JoVE61007 Manuscript: Terahertz Imaging and Characterization Protocol for Freshly Excised Breast Cancer Tumors

The authors would like to thank the Editor, Associate Editor, and Reviewers for their consideration and comments on this manuscript. We have responded to all comments/suggestions provided by the editor and the Reviewers. Changes to the manuscript have been highlighted both in this letter and in a revised file for the manuscript.

Figure 3: THz transmission spectroscopy module set-up. (A) THz core chamber with the transmission module mounted on it. (B) The photograph of the liquid sample holder. (C) The sample holder placed inside the core chamber for the measurements.

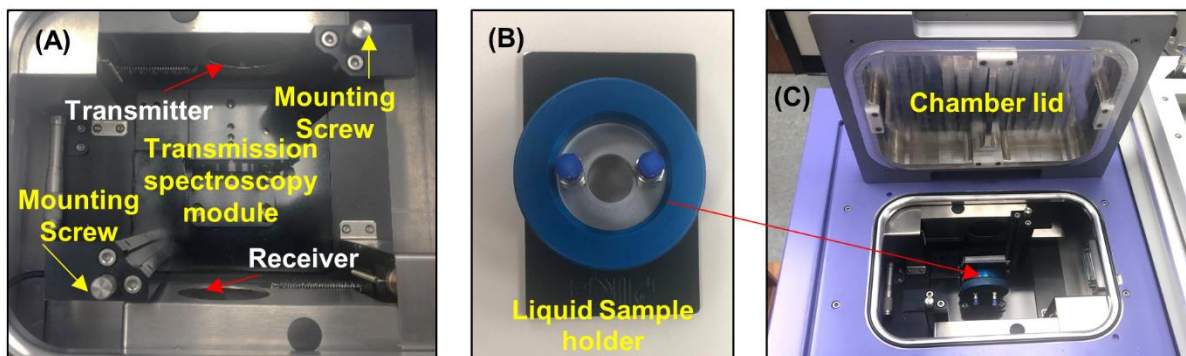
Comment 8: 2.3.1, 2.3.5: How is this done?

Response: The setting of the module mentioned in step 2.3.1, which is now renumbered as 3.1, is performed by mounting it inside the core THz chamber and locking it down by tightening the two mounting screws. The mounting screws are depicted in the modified Figure. 3A.

“Set the transmission spectroscopy module inside the THz core chamber by aligning the module handles over the mounting posts in the core system and sliding the stage down into the system. Tighten the two mounting screws in the upper right and lower left corners of the module as shown in Figure 3A.”

“Figure 8: Photograph of the biohazardous waste bag.”

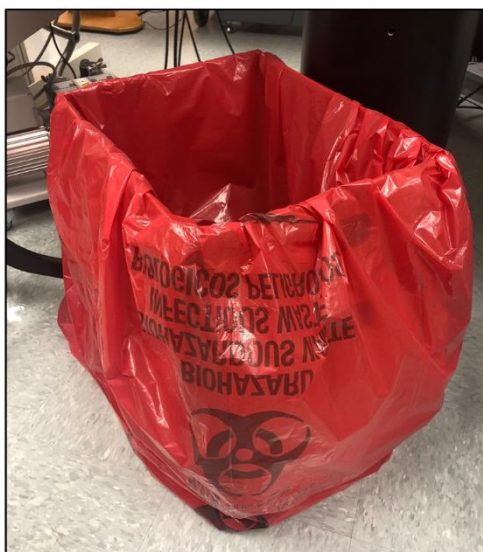
Comment 10: Please ensure that you have a result for each section of the protocol.

Response: We have presented and discussed the results for both the methods described in the protocol, THz transmission spectroscopy (Sections #3 and #8) and THz reflection imaging (Sections #4 and #7), for the characterization and imaging of breast cancer tumors. It is to be noted here, that Sections 1 and 2 in the protocol are for tissue handling which are necessary to be done to get to the Sections 3 and 4 in the protocol which provide detail on the experimental methods. Similarly, Section 5 and Section 6 are the post processing steps upon completion of the experimental methods. The figures are added in these sections itself to make it easy for the readers instead of presenting them in the results section. A new figure (**Figure 8**) and the corresponding legend has been added for Section 6 in the manuscript. It is to be noted, that with the addition of Figure 8, the numbering of all the figures following Figure 8 are altered and highlighted in the manuscript accordingly.

“[Place **Figure 8** here].”
